Changeover of the locking hook for the solder flange pin of the S2C-SMT 3.50 and S2L-SMT 3.50

Type of notification: PCN PDN Short-term action

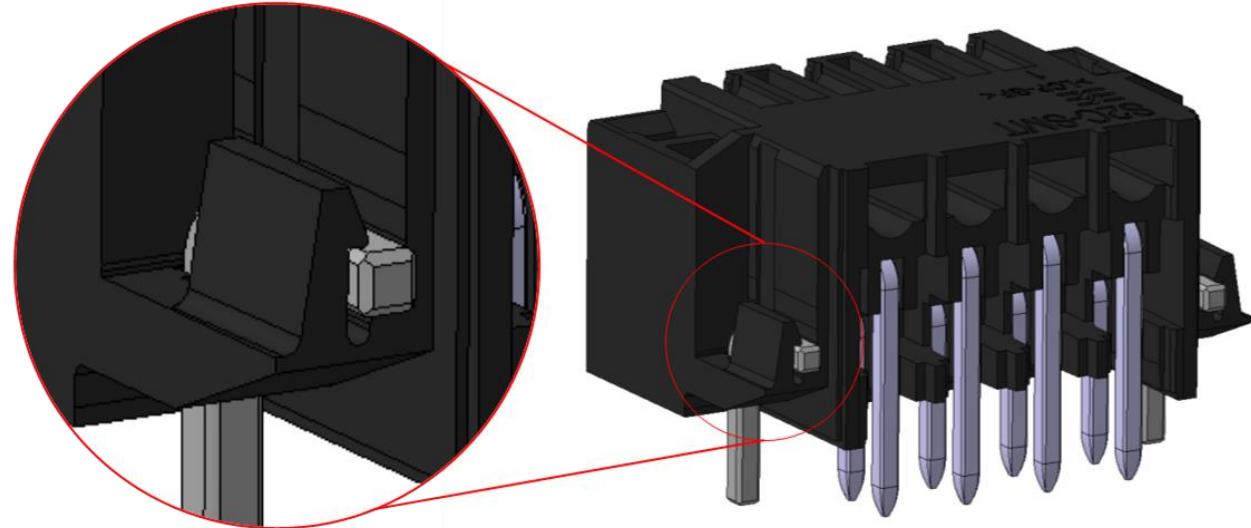
The geometry of the locking hook for fixing the solder flange pin of the S2C-SMT 3.50 and S2L-SMT 3.50 has been optimized. The new shape ensures a stable and locked hold of the solder flange pin. Furthermore, the new geometry is designed to be more robust against external forces.

Old locking hook for the soldering flange pin

New locking hook for the soldering flange pin
